Submissions Report

SSD-97528708 – Mixed-use Development with in-fill Affordable Housing

142-148, 160 Oxford Street, 13 Gipps Street, 6 Shadforth Street,
Paddington

17 June 2026 | 2250501

Figure 4 Site Plan of Existing Residential Flat Building at 160 Oxford Street

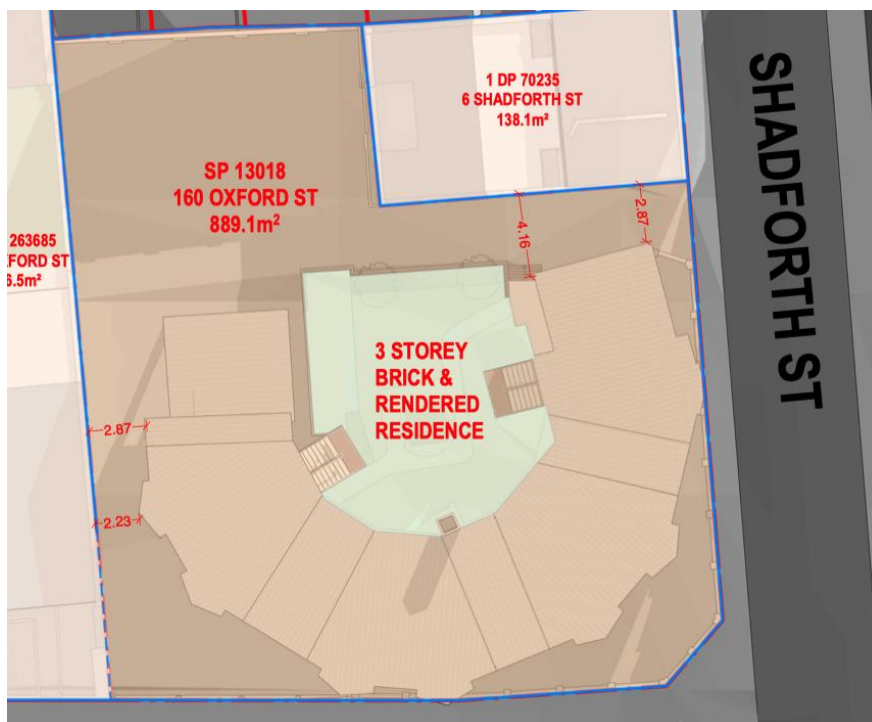
- Currently, the existing building provides inadequate building separation to its northern and western interfaces. Its northern boundary provides a varied setback between 2.87m-4.16m and the western setback is approximately 2.23m-2.87m as shown in **Figure 4** below.

- Accordingly, the minimum separation distances between the respective interfaces are not presently achieved, resulting in further privacy and overlooking impacts.

Figure 8 Line of sight analysis following inclusion of balcony planters

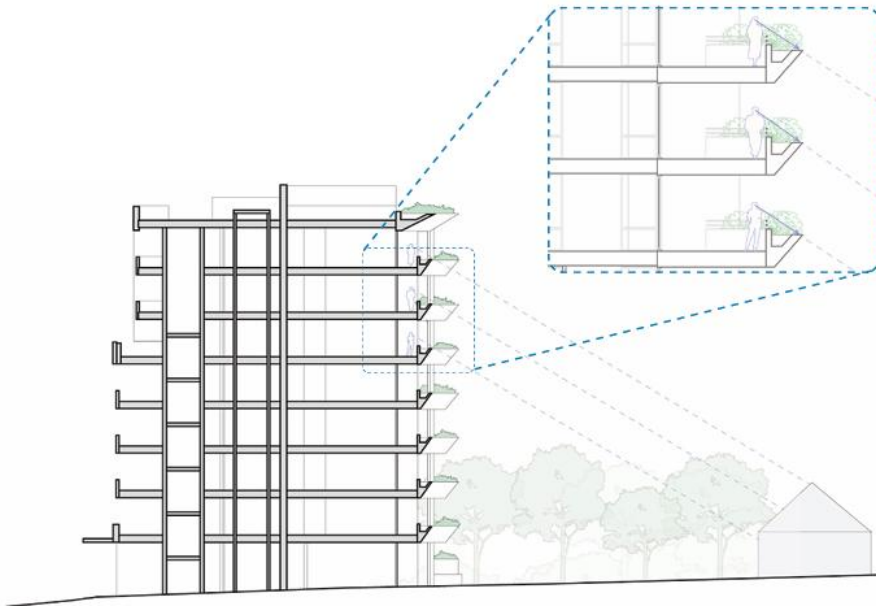
Item	Matter	Response
	<i>a. provide additional setbacks or visual privacy measures for balconies (level 5 and above) along the northern elevation that are setback 9 m from the boundary, instead of 12 m recommended for high density developments adjoining a low - density zone (Part 3F of the ADG)</i>	additional 3m of building separation as suggested by the ADG design guidance. Further detail is provided in Section 5.9 below.
DPHI-14	<i>b. increase the setback of the terrace to Apartment L1.07 from the western boundary or provide additional visual privacy measures (via non -trafficable areas, screens or planting) to alleviate any overlooking opportunities due to the location of this terrace within the recommended side setbacks (Part 3F of the ADG)</i>	The amended Architectural Plans (Appendix B) demonstrate that the Level 1.07 apartment (now apartment 1.08) balcony has been shifted to the east, enabling the inclusion of a planter as a visual privacy measure to minimise potential overlooking.

- Provision of planters on the northern facade such that line of sight to the backyards and windows of properties on Gipps Street to the north are obstructed (see **Figure 8**), thus ensuring visual privacy through design measures rather than providing an additional 3m setback recommended for high density developments adjoining a low -density zone.

Figure 11 Publicly Exhibited 3D Axonometric (view from southeast)

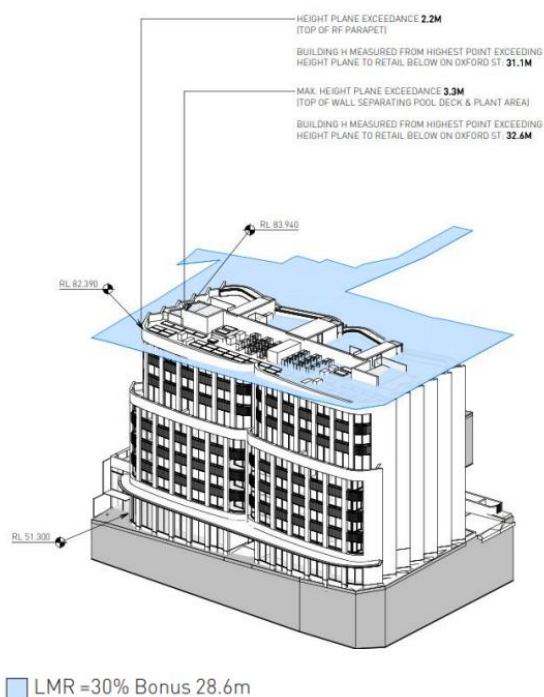
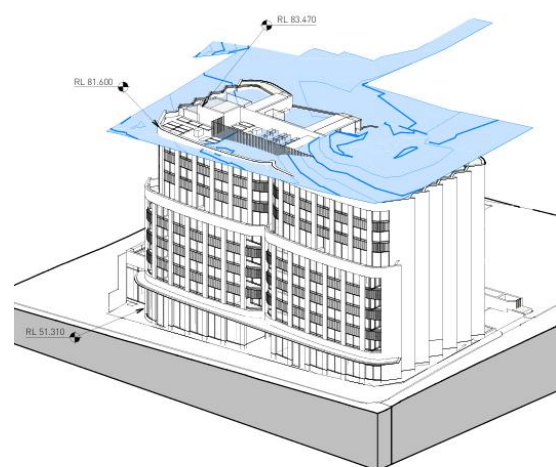
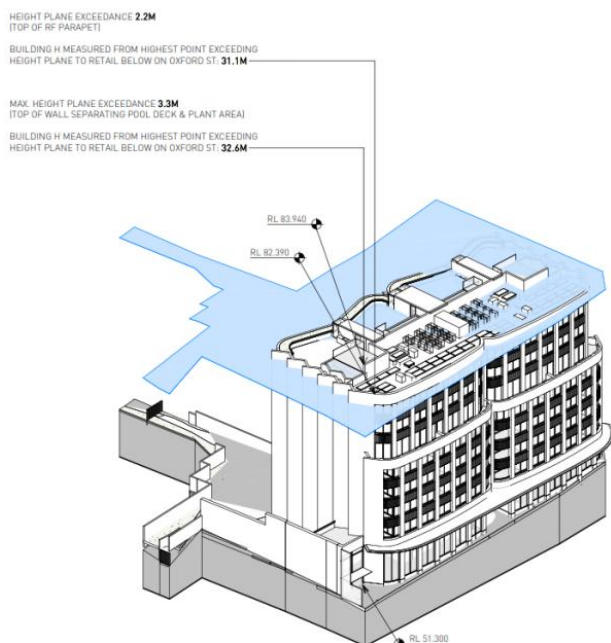
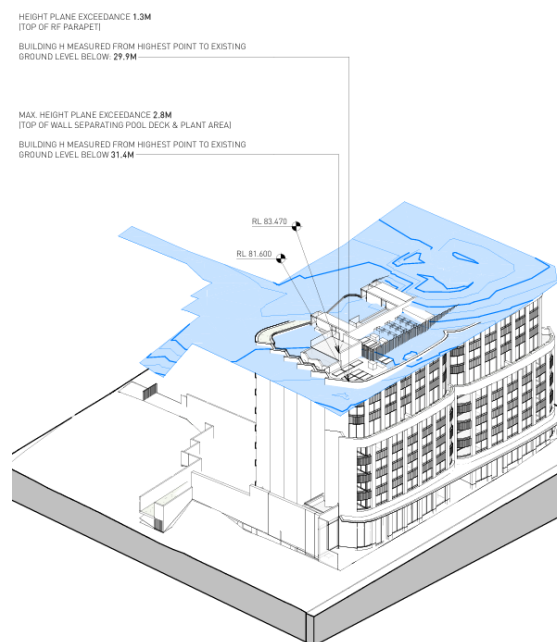
Building height		
DPHI-17	<i>Provide amended architectural plans (including elevation and cross-section plans) to include annotation of the existing RL(s) directly below the highest point(s) of the buildings.</i>	The sections within Architectural Plans have been amended to show the RLs directly below various points of the building. The maximum height is RL 83.47. In response to submissions, the proposed maximum building height has been reduced from 32.6m to 31.4m. Further detail is provided in the Amended Clause 4.6 Variation Request for Building Height (Appendix S).
DPHI-18	<i>Provide an amended height plane diagram with annotation of the extent of the building height breach (in RTLs and in meters) based on the existing ground level RLs.</i>	The amended height plane diagram is provided within the Updated Architectural Design Report (Appendix C), and annotates the extent of height exceedance. These are based on a height plane that has been extrapolated using multiple surveyed RLs within the site, which is also shown within the Updated Design Report (Appendix C).

Most importantly, this significant height decrease is attributed to the reduction in floor-to-floor height from 3250mm to 3200mm. Furthermore, the lower Ground Floor unit has been removed, resulting in an 8-storey development as opposed to an 8-9 storey building. Additionally, roof plant equipment has been redistributed within the building. Notably, some taller mechanical plant equipment that previously contributed to the height exceedance has been relocated to the mezzanine area at the lower ground level.

The proposed changes to the building height are illustrated in the side-by-side comparisons below, which also incorporate the site's topographic contours to enable a detailed assessment.

As illustrated in **Figure 11-Figure 14**, this has resulted in the entirety of the eastern portion of the building being below the maximum building height plane, with exceedances limited to the parapet of Level 8, portions of rooftop plant, solar panelling, rooftop amenity structures and stairway overruns. Notably, the height variation is predominantly a result of the uneven topography of the site with an approximate fall of 3- 5m (Refer to **Appendix B**).

Figure 17 *Proposed overshadowing to Victoria Barracks*

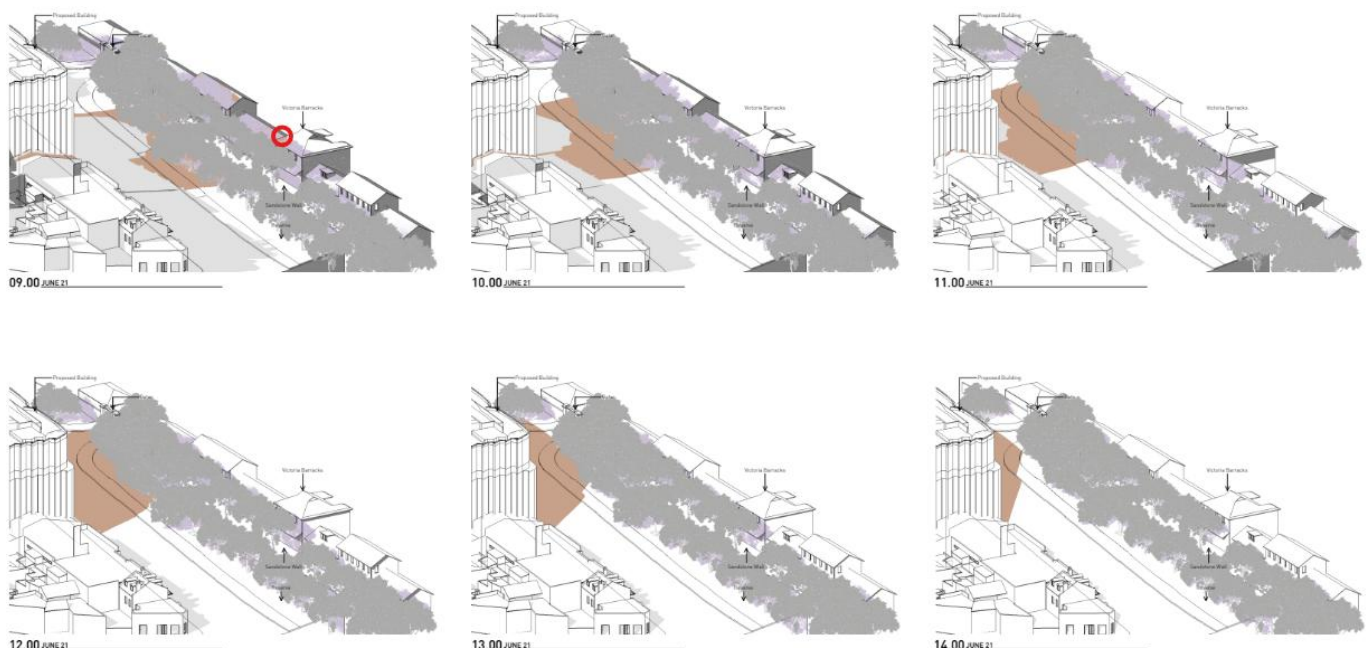
DPHI-9	<i>b. impacts of the additional shadows cast on these structures due to the proposed development</i>	The impacts of the additional shadows cast to the above buildings is provided within Section 5.8 and in the updated Architectural Plans at Appendix B .
DPHI-10	<i>c. additional assessment of the impacts of the development on the heritage significance of Building 13 (National heritage significance) including any impacts on views from this building.</i>	Additional assessment of the heritage significance of Building 13 is provided in the addendum Statement of Heritage Impact (Appendix G) and further addressed within Table 8 which contains responses to the referral from the Department of Climate Change, Energy, Environment and Water. Additional detail is also provided in Section 5.6 .
Visual Impact Analysis		
DPHI-11	<i>Provide an updated visual impact analysis, with additional views from various viewpoints within the Victoria Barracks site. Please contact Heritage NSW (provided in the agency comments) to access this site</i>	An amended Visual Impact Analysis has been prepared by Colliers Urban Planning at Appendix O. It is noted that GBA Heritage, on behalf of the Applicant, attempted multiple times to gain access into the Barracks Precinct with assistance from Heritage NSW to set up at least one location for a Visual Impact Assessment. However, access was not granted by the Commonwealth. As this was unachievable, GBA Heritage reached out to DPHI to seek an alternative solution to address this requirement. On 22 April 2026, DPHI advised that they had met with HNSW to close out this issue. HNSW indicated that they would be satisfied if there was an additional VIA viewpoint in the Oxford Street streetscape, from next to the Barracks Wall closest to Building 13. In accordance with this advice from DPHI, an additional viewpoint (No. 8) has analysed and added to the updated Visual Impact Assessment.

Moreover, as illustrated in **Figure 17**, rows of mature trees within Oxford Reserve and between the Barracks wall and the subject buildings already cast shadows onto the subject buildings as seen in purple in **Figure 17**. The perimeter wall itself also throws shadows onto the intervening space and onto portions of the subject buildings. Even without the existing trees, the originally submitted shadow diagrams show that the façade of the buildings within the Victoria Barracks would be overshadowed between 9am and 10am by a development under the LMR 22m height controls.

As illustrated in **Figure 17**, overshadowing to Buildings 94-96 that are not already overshadowed by the existing trees, is limited to small portions of the roof of those buildings between 9-10am.

As shown in the Clause 4.6 Variation Request, the extent of additional overshadowing from the parts of the building that exceed the height limit is very minor.

Figure 22 *Proposed Awning and Setback from Trees 2-5*

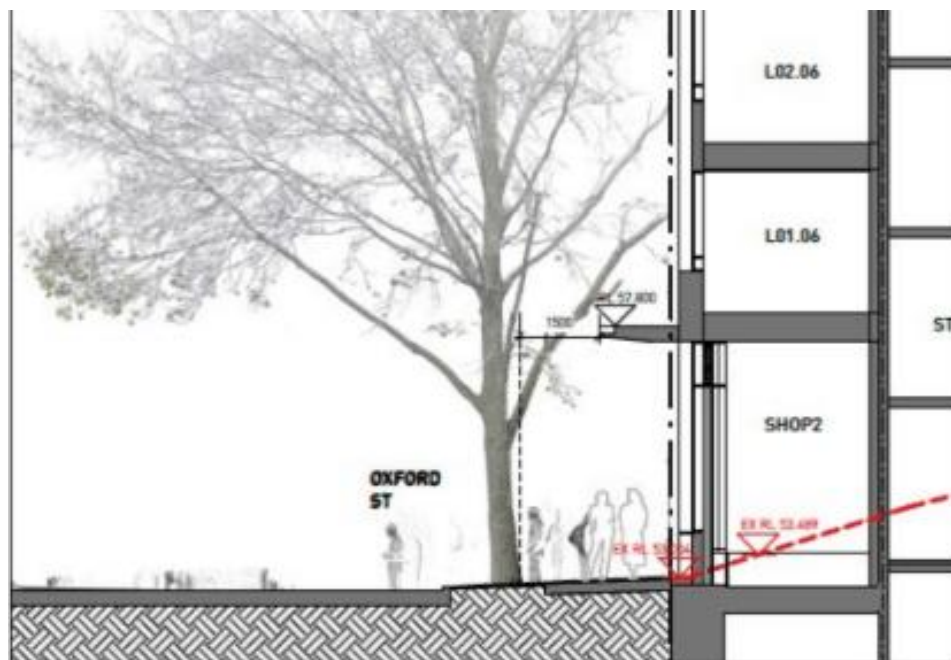
TMS Tree Management Strategies have confirmed that Trees 2, 3, 4 and 5 will be affected by additional impacts from the 1.5m wide scaffolding/hoarding required for the construction of the development. Accordingly, pruning of Trees 2-5 is required to facilitate this work zone adjacent to the trees for construction access. The submitted awning design had the

potential to impact Trees 2-5. Comparatively, the amended awning design has been reduced to ensure a 1.5m setback from the centre of Trees 2-5, as shown in **Figure 22**.
